Revision of Manuscript Number: IEEE-TPWRS-01391-2021, version 1 January 6, 2022
Journal: IEEE Transactions on Power Systems
Author: Abhishek Halder, Kenneth F. Caluya, Pegah Ojaghi, Xinbo Geng

Response to decision:

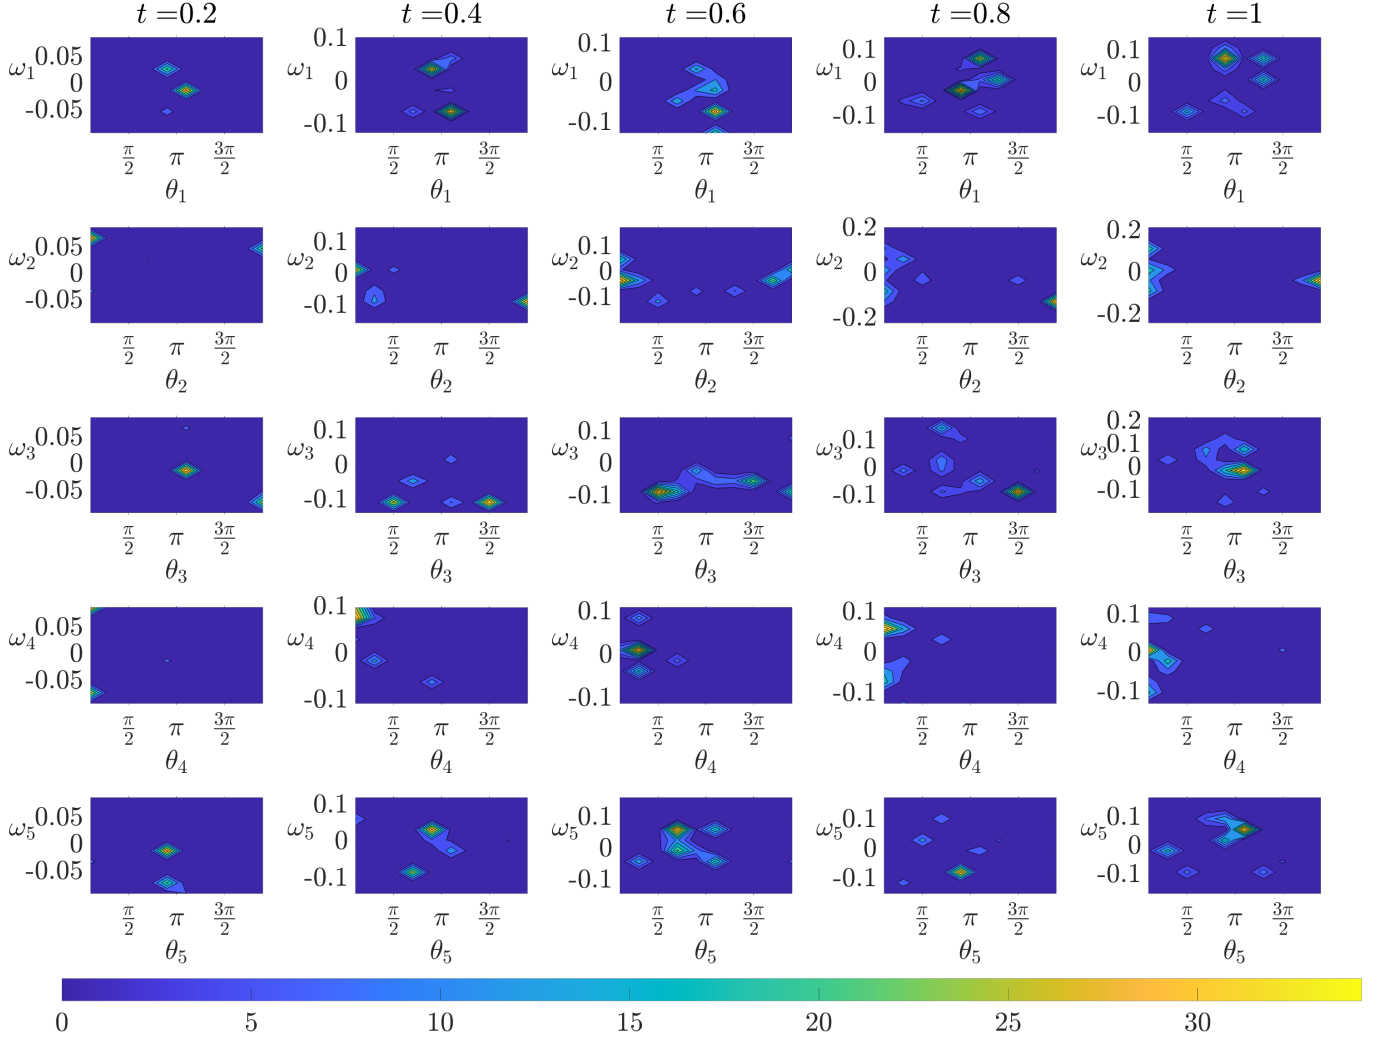
Figures 5 and 6 are unreadable.

Response: Thanks for this comment. In the previous version, the strict 10 page limit enforced small figure sizes. In the revised manuscript, Figures 5 and 6 are made larger. Also, the Fig. 6 in the revised manuscript shows the transient (θ_i, ω_i) bivariate marginals for all the five generators in Case II; the previous version showed the same only for the generator 4 (bus 6). We believe these changes have improved clarity.

Regarding the style of plots, we had considered plotting the bivariate marginals as planar contour plots (as in Fig. 1 in this rebuttal document) but decided against it because of the following two reasons.

First, in our opinion, this kind of plot is scientifically misleading as they hide the fact that these bivariate marginal PDFs are not really supported on the plane, or the subsets thereof, but instead have cylindrical supports. Our message that the proposed method explicitly accounts this manifold geometry in the computation, would be missed had we chosen to make the plots as per populist cognitive bias on behalf of the readers. That the planar plots evoke a sense of familiarity cannot be a scientific argument in favor of it.

Second, the planar contour marginal plots require additional mental efforts from the readers to correctly parse the statistical information conveyed. For instance, consider the fourth column, second row subplot in Fig. 1 in this rebuttal document. It is upon the reader to parse that the two high probability regions on the left and right of that subplot are actually referring to the same angular high probability region around $\theta_2 = 0$ rad, thanks to the periodic boundary condition on the angular variable. Our philosophy of technical communication is that the onus is on the authors, not on the readers, to clarify the scientific information as correctly as possible. And yes, we are aware that many papers in the power system literature make plots in the rectangular domain ignoring the manifold nature of the support, which in our experience, continue to add pain to the graduate students and beginning researchers trying to decipher the statistical meaning conveyed in those plots. We prefer ours not be contributing to the accrual of such pain, and instead make plots that depict the variables as they are.
